**In the United States Patent and Trademark Office**

**For:** Self-Route Expandable Multi-Memory Packet Switch with Distributed Scheduling Means

**Serial Number:** 09/683,429

**Response and Amendment Under 37 C.F.R. §1.111**

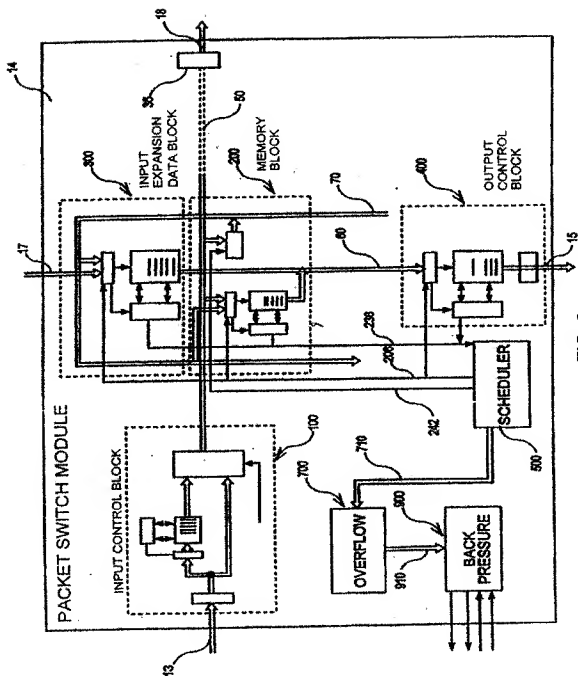
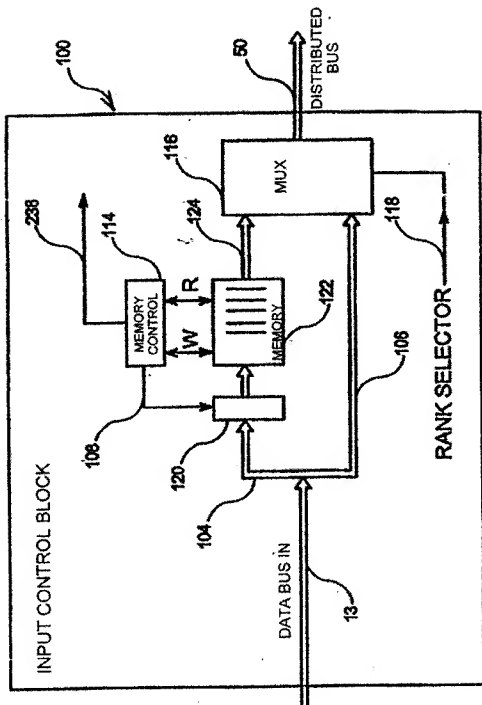
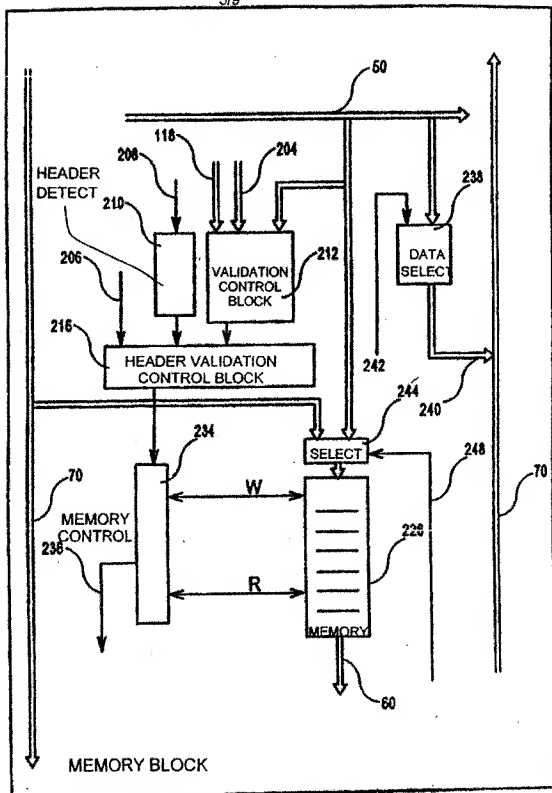
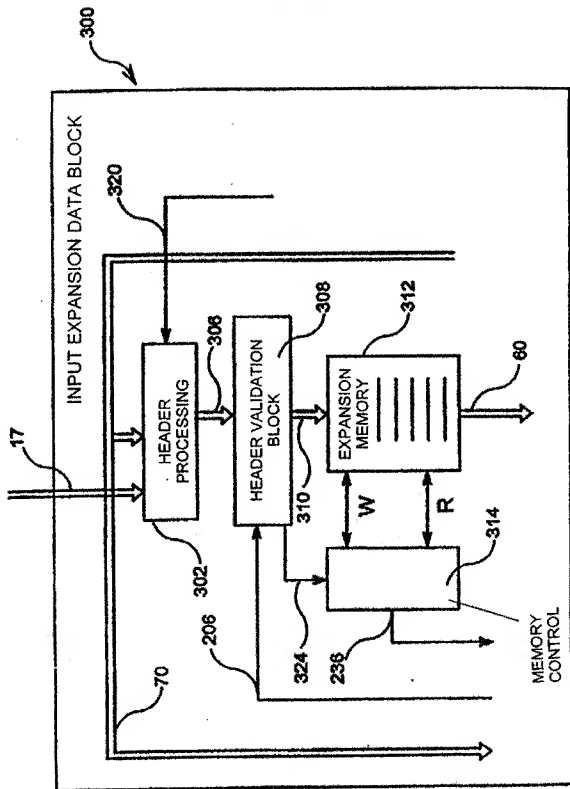
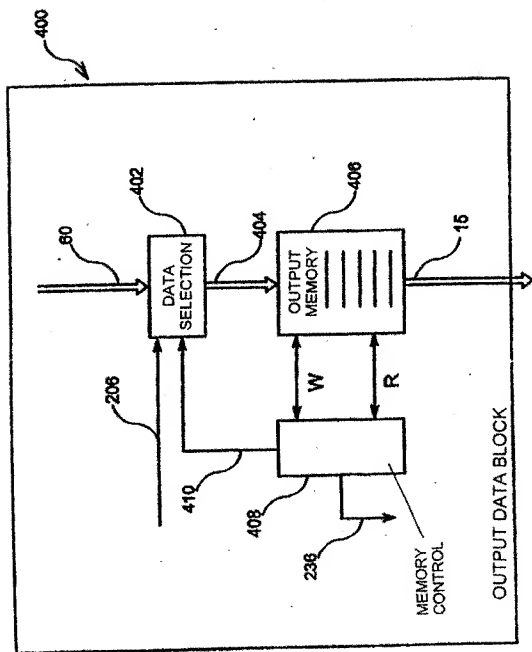
The Office Action stated an objection to Figures 3-8 as failing to comply with 37 CFR 1.121(d) because descriptive labels necessary for understanding the drawings are missing. The Office Action also stated that the quality of the connections shown on Figure 8 is not acceptable. A proposed set of drawings to overcome the objections is attached to this amendment as Appendix A. Each sheet has been labeled "Replacement Sheet" to be in compliance with 37 CFR 1.121(d).

Therefore, Applicants respectfully submit that the objection to the drawings has been overcome.
